J2219A-02

ADMINISTRATIVE INFORMATION

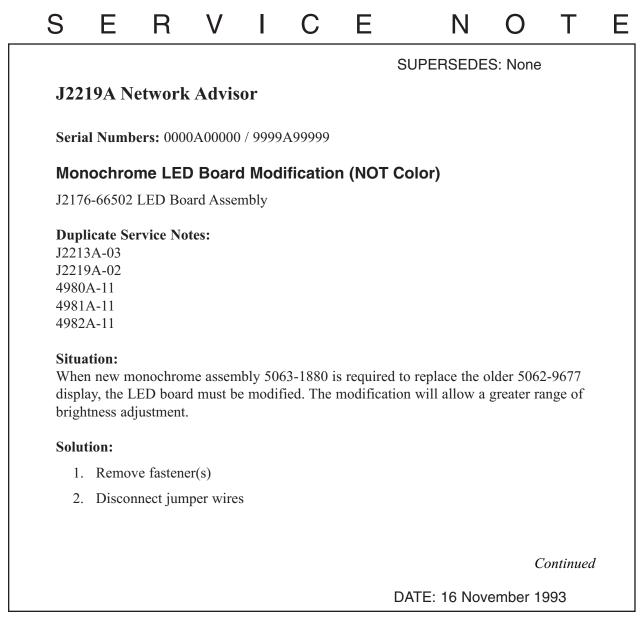
- 3. Carefully snap out LED display board assembly
- 4. Locate jumper and remove at one of either location as shown in the diagram

- 5. Reinstall wires/fasteners and board assembly
- 6. Test brightness operation
